Utility Conflict Report

OWNER	Utility	CPS	Corridor	SW MILITARY	SITE PHOTOS   		
	Contact	JAKE MARTINEZ	ID	4118			
GENERAL INFO	Utility	ELECTRIC					
	Size and Material	STANDARD POWER POLE, TIMBER					
	Accessible Route	ASSET IS INSIDE ACCESSIBLE ROUTE					
	Longitudinal or Crossing	CROSSING					
	Placement Relative to ROW	INSIDE ROW					
LOCATION	Sheet No.	135					
	Station	560+94.65					
	Offset	15.23					
	Latitude	+29.357315					
	Longitude	-98.55073					
SUE	Level of Investigation Req'd	NONE					
	Test Hole No	N/A					
	Test Hole Depth	N/A					
RESOLUTION	Recommended Action	ACCOMODATE - RELOCATION					
	Estimated Resolution Date						
	Resolution Status	UTILITY OWNER INFORMED OF UTILITY

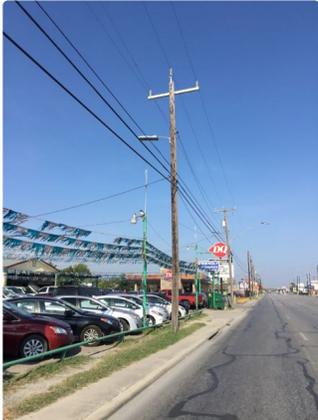
Comment	Pole ID: LA1785410 Pole to back of curb = 2'-10" Sidewalk width = 3'-0" Pole to steel rail = 2'-4" Relocate pole to ROW with electric lines cantilevered toward the roadway					
Date Collected		7/27/2018 9:13:42 AM		Date Modified		11/21/2018 2:51:37 PM
